Access Compliance Report

Public Rights-of-Way

Intersection ID: 13382	Main Street: E_CATHERINE_ST	Cross Street: S_COLLEGE_ST	Location: NE
ADA ID: 5801E645440F	Ramp Type: Perp	Initial Pass/Fail: Fail	Overall Compliance: No
Severity Score: 13.75			
Codes/Mitigation Info/Possible Solution		Field Measurements/Component Compliance

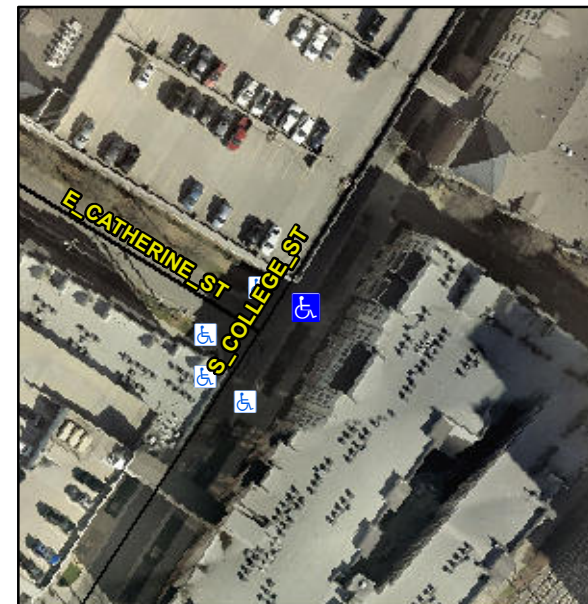
Not Found, R304.2.2

Compliance	Description	Data	Compliance	Description	Data
N/A	Ramp Length (in)	94.0	No	Ramp Slope (%)	8.9
Yes	Ramp Width (in)	48.0	Yes	Ramp XSlope (%)	4.2
N/A	Flare Type LT	N/A	N/A	Flare Type RT	N/A
N/A	Flare Slope LT (%)	N/A	N/A	Flare Slope RT (%)	N/A
N/A	Flare Traversable LT?	N/A	N/A	Flare Traversable RT?	N/A
N/A	Landing Length (in)	N/A	N/A	DWS Provided?	N/A
N/A	Landing Width (in)	N/A	N/A	DWS Contrast?	N/A
N/A	Landing Slope (%)	N/A	N/A	DWS Length (in)	N/A
N/A	Landing X Slope (%)	N/A	N/A	DWS Full Width?	N/A
N/A	Landing Curb? (Y/N)	N/A	N/A	DWS Offset (in)	N/A
N/A	Shared Landing?	N/A			
N/A	Gutter Ponding?	N/A	N/A	Gutter Slope (%)	N/A
N/A	Gutter Lip Ht (in)	N/A	N/A	Gutter X Slope (%)	N/A
N/A	Painted X Walk1?	No	N/A	Painted X Walk2?	N/A
	X Walk 1 Direction	To NW		X Walk 2 Direction	N/A
N/A	X Walk 1 Width (in)	N/A	N/A	X Walk 2 Width (in)	N/A
	X Walk 1 Slope (%)	0.3		X Walk 2 Slope (%)	N/A
	X Walk 1 X Slope (%)	5.0		X Walk 2 X Slope (%)	N/A

Remove & Replace Entire Ramp.
